Re: Bayou Midstream Bakken, LLC (NST Express, LLC) Written Response to Notice of Probable Violation; CPF 3-2022-056-NOPV

This letter relates to the Notice of Probable Violation Proposed Civil Penalty and Proposed Compliance Order ("NOPV"), issued by the Pipeline and Hazardous Materials Safety Administration ("PHMSA"), dated November 8, 2022, alleging certain violations at the crude oil pipeline system between East Fairview, MT and Alexander, ND, that was owned and operated by NST Express, LLC ("NorthStar") at the time of inspection and is now owned and operated by Bayou Midstream Bakken, LLC ("Bayou").

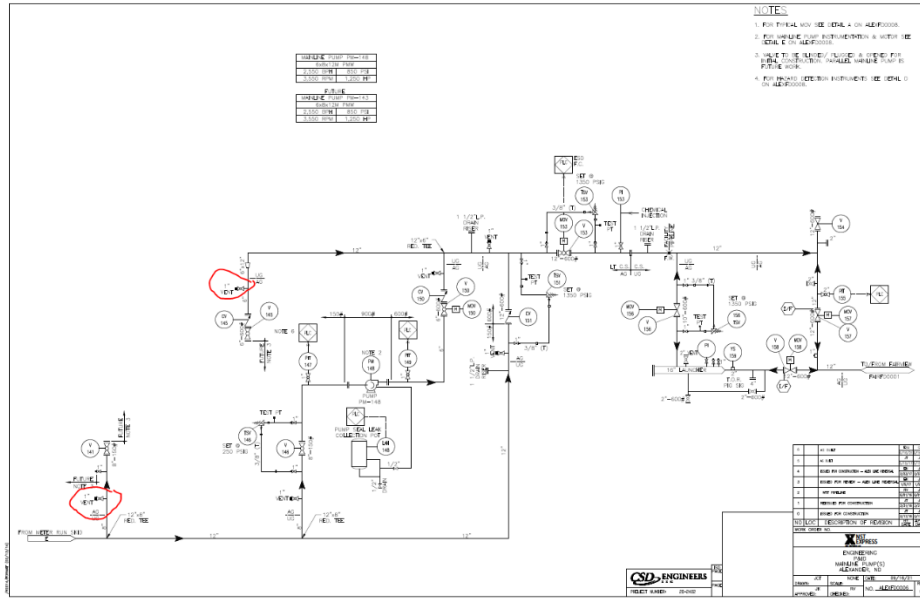
Alleged Inadequacy: NST failed to monitor the effectiveness of internal corrosion control measures in a segment of pipe at its Alexander station. During the field inspection, PHMSA identified a segment of pipe with no flow and without a corrosion coupon. Although NST uses inhibitors to prevent internal corrosion and has coupons in segments with flowing product, it was not able to properly monitor the no-flow segment.

During a review of records and maps of the Alexander Station, PHMSA found that NST built a line segment to accommodate a second pump that was not yet installed. There was no coupon in this section of pipe, and it was not adequately protected or monitored for internal corrosion.

Response: Bayou will install corrosion coupons at the two vents in the line indicated in Inadequacy 6 as shown in the image below. The coupons will be installed in the two circled vents and will be monitored as part of our corrosion coupon monitoring program. The install cost for these two corrosion coupons will be ~\$2,400 each.
